Office Action Summary

10/532,332

Detailed Action

Fig. 1

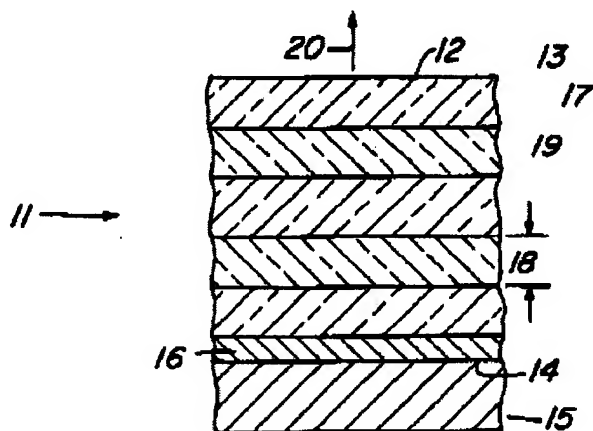
15. Bushman teaches an infrared light source (Note Figure 1 below) that includes energy source 15 that emits radiation through a multi-layered filter having an optical thickness selected to be one-quarter of the wavelength for the light 20 to be emitted. As the light passes through a boundary between alternating layers of different indexes of refraction it is partly refracted, and partly reflected, such that the transmitted light will be at one wavelength while the rest of the wavelengths will not transmit nor emit through the filter. Col. 3, line 37-67; and Col. 4, line 1-14.

16. Bushman modifies Bayly to provide a source that emits a laser-like monochromatic light at a selected wavelength in the infrared region determined by the optical thickness of the layers of the emitter member, while light at other wavelengths are not transmitted.

17. Therefore it would have been obvious to one of ordinary skill at the time the invention was made that Bayly would use the emitter of Bushman to provide a source that emits a laser like monochromatic narrow beam of light at a selected wavelength.
